April 19, 2022
File No. 25216186.00

Subject: Addendum to Site Investigation Report
Arctic Laundry & Cleaners (former)
5619 22nd Avenue, Kenosha, Wisconsin
BRRS #02-30-245843

SCS Engineers (SCS) is providing additional information requested in your April 4, 2022 email for the above-noted Arctic Laundry & Cleaners case. The information you requested is shown in bold italics below followed by our response.

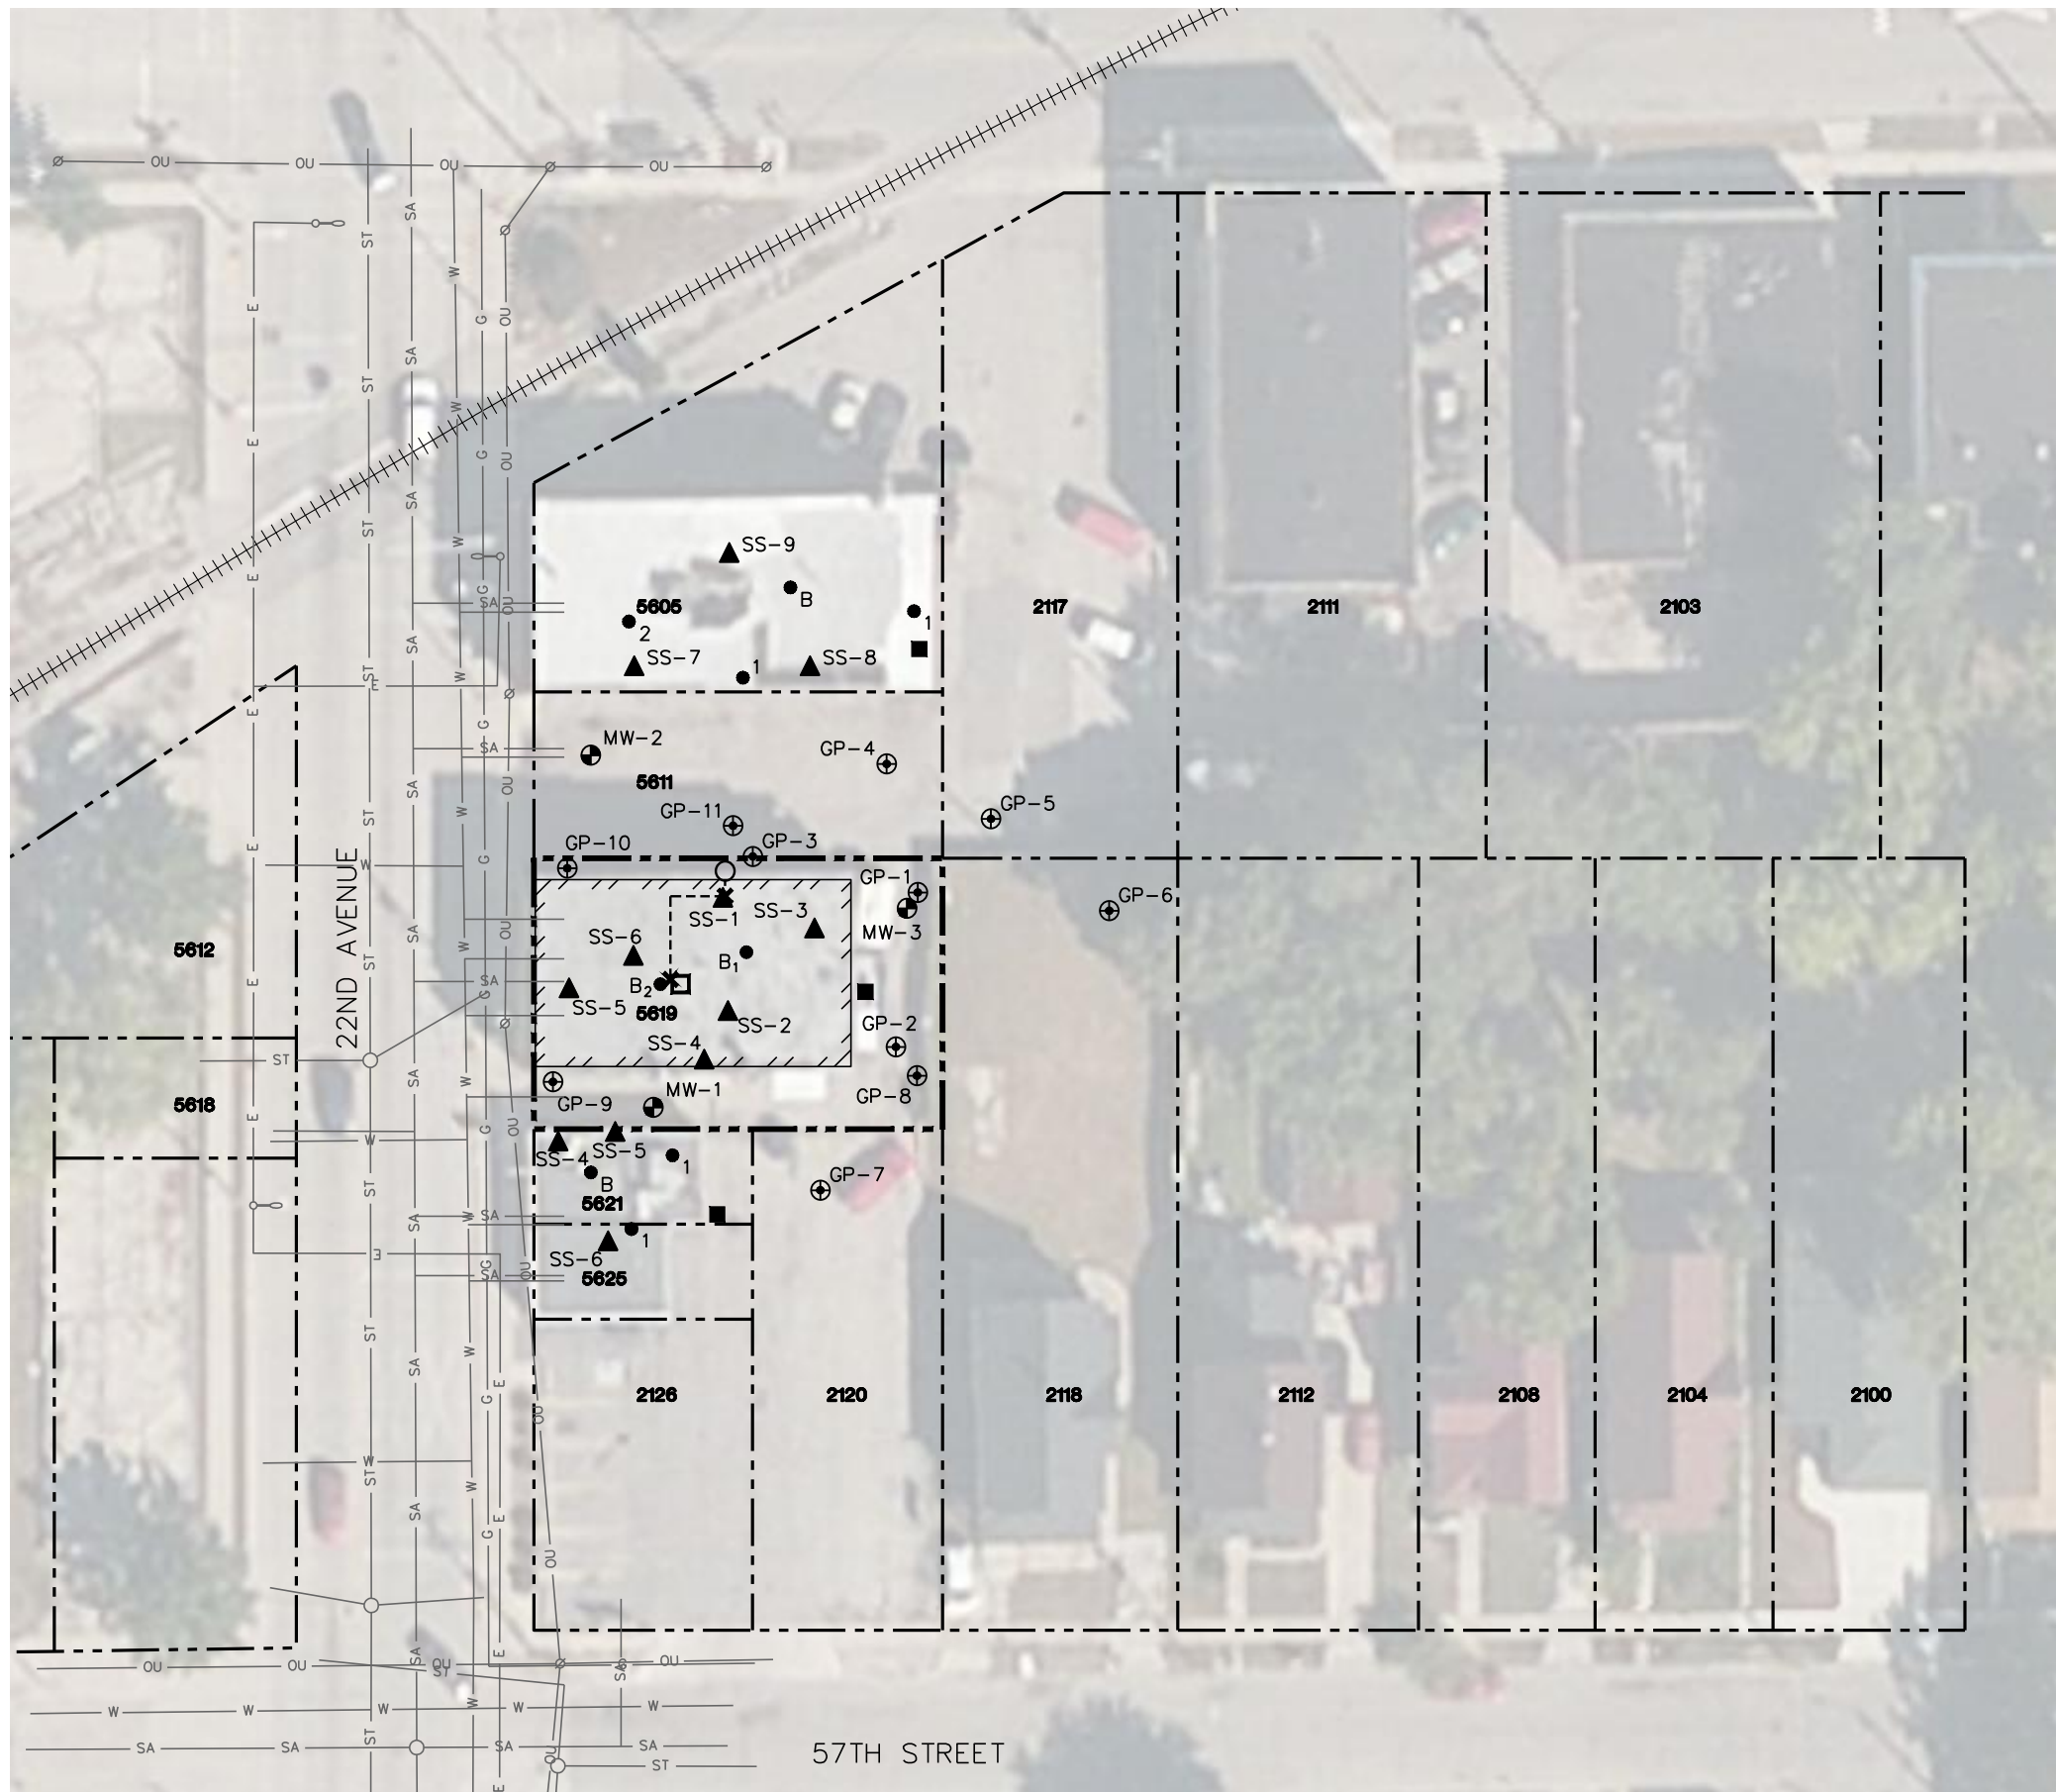
Notification letters provided to off-site owner regarding 2018 sample results. Explain how building residents of the former Arctic building are notified of the results.

Indoor air samples locations are shown on **Figure 1** and revised Site Investigation Report (SIR) **Figures 2** and **8**. The indoor air sample locations were selected based on accessibility and communication with the owners and tenants. The sample canisters were placed away from windows, doors, or vents to the extent practical in order to limit influence from outdoor air. The samples were collected over multiple seasons, including the “heating season” where windows and doors are typically closed and there’s a higher risk of vapor intrusion.

FIGURE 1

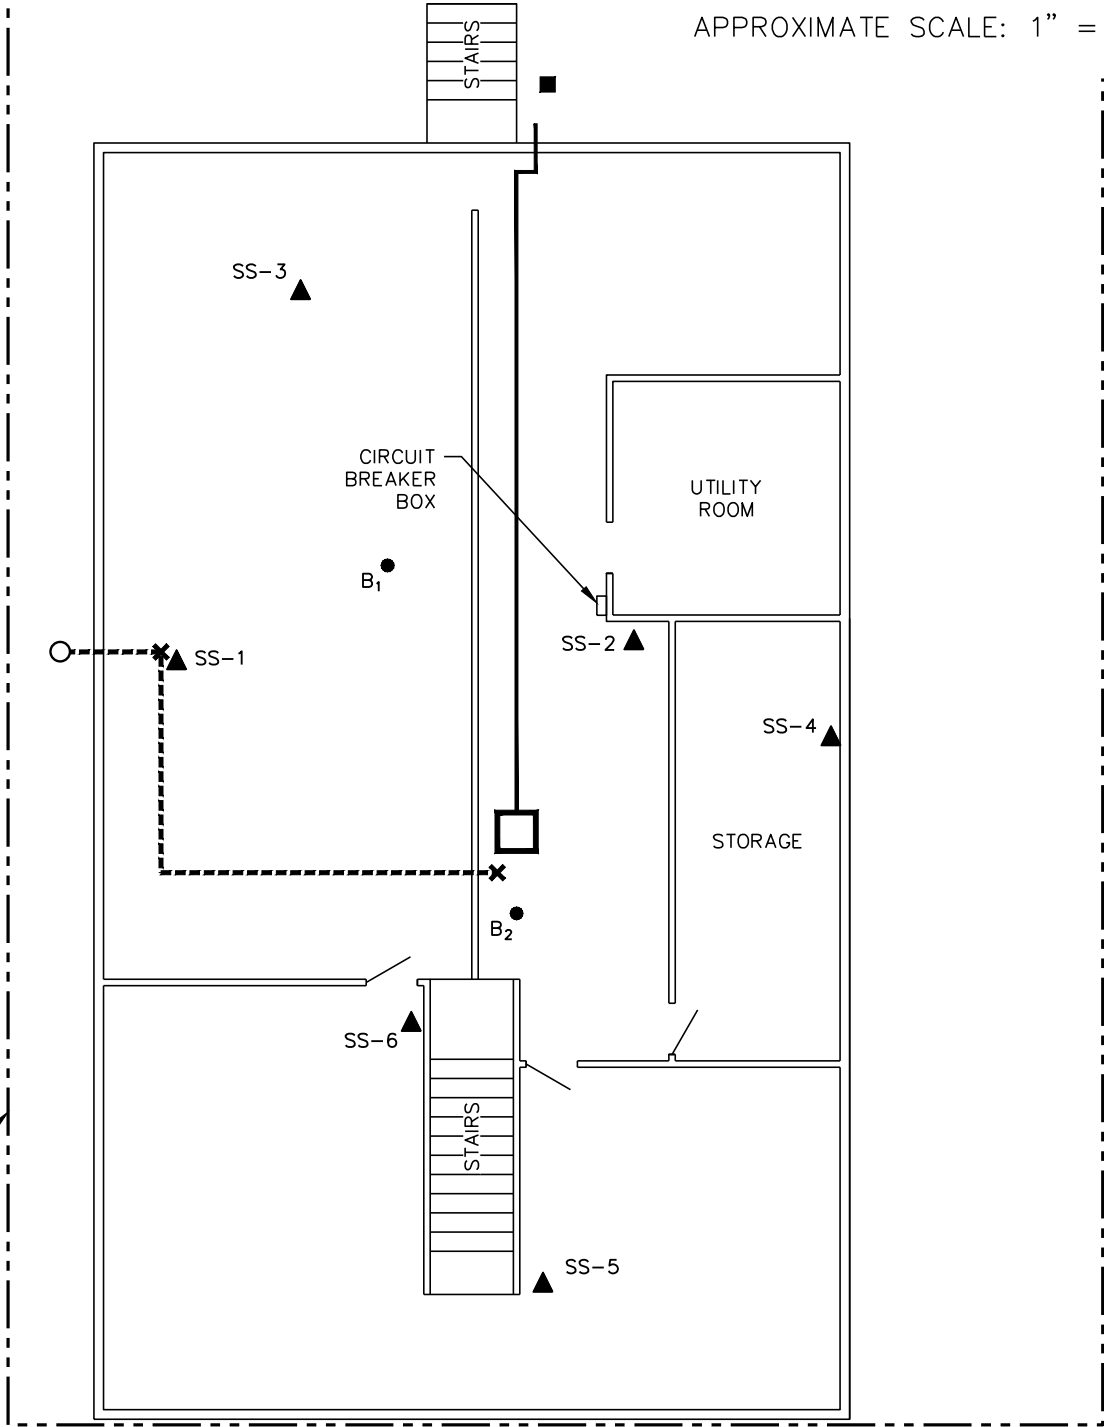
A map showing where sub-slab pressure readings were measured to determine the effectiveness of sub-slab vapor mitigation and a table summarizing these readings.

A site figure that identifies where the sump discharge pipe is located and where the discharge water flows to. Also confirm whether the sump water has been analyzed and discuss the potential for the sump discharge to impact areas outside the building.

A map showing where sub-slab pressure readings were measured is provided as **Figure 1**. Sub-slab vacuum measurements are summarized in **Table 1**.

Photos of the sump and discharge piping were provided in our March 24, 2017 update. The sump location and piping are shown on attached **Figure 1**. The sump water has not been sampled. Other than the original tetrachloroethene (PCE) spill in 1994, SCS is not aware of any other significant discharges to the sump that would have impacted areas outside the building.

The sump is located in the middle of the basement floor, and according to our prior communications with Mr. Ekornaas, has a solid bottom without a drain. The sump pump is connected to a plastic pipe which runs overhead to the east side of the building.
